Title: MEETING WITH ADVISORY COMMITTEE ON REACTOR SAFEGUARDS (Public)

**U.S. NUCLEAR REGULATORY
COMMISSION MEETING WITH
THE ACRS**

December 6, 2019

Figure 1. Estimates of the residual (RG 1.99, Revision 2 predicted minus measured values) of $\Delta\text{RT}_{\text{NDT}}$ using the current US and international database for (a) welds and (b) base metal.

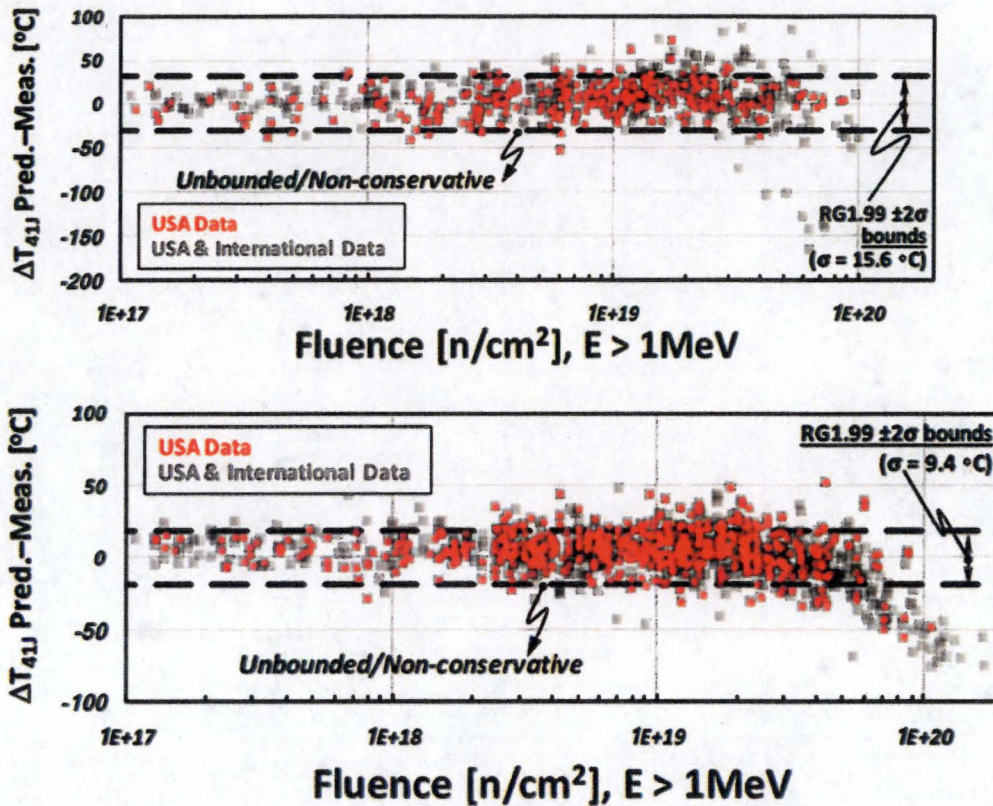
- Non-conservatism at high fluence for base metals
- Inaccuracies for reactor vessel materials with low copper content
- Underestimated standard deviation relative to the current database
- Conservative bias at low-to-mid fluences
- Lack of temperature adjustment

These deficiencies raise potential safety margin issues because resulting estimates of reference nil-ductility transition temperature shift (ΔRT_{NDT}) may be non-conservative for plants with vessels exposed to higher levels of neutron fluence anticipated during subsequent license renewal. Figure 1 contains plots of the residual of ΔRT_{NDT} for both welds and base metal. Residuals are computed as the difference between the RG 1.99, Revision 2 predicted value and the measured value from the current large embrittlement data base, incorporating both US and international data. A negative residual value indicates non-conservatism. The technical letter report analysis suggests that between fluences of 3×10^{19} n/cm² and 6×10^{19} n/cm² ($E > 1$ MeV), the mean residual becomes increasingly non-conservative.

Standard deviation values from the RG are used as a defined margin in RPV embrittlement calculations (horizontal dash lines in Figure 1). The current large embrittlement database has a larger standard deviation (greater scatter) than the original database used to develop the ETC in the RG. This represents another potential non-conservatism.

The staff working group has adopted the correlation in ASTM E900-15. Completion of the tasks identified by the working group will provide a sound basis for revision of the RG. The working group also presented a schedule for completion of the identified tasks and development of a draft revised guide.

The oversight group is charged with overall supervision of the effort and to provide guidance on implementation. Given that each plant has a different operating temperature, material chemistry, and projected end-of-life fluence, the oversight group should develop an implementation path forward considering each plant's situation. This would eliminate unnecessary burden on plants for which RPV limits are not challenged.
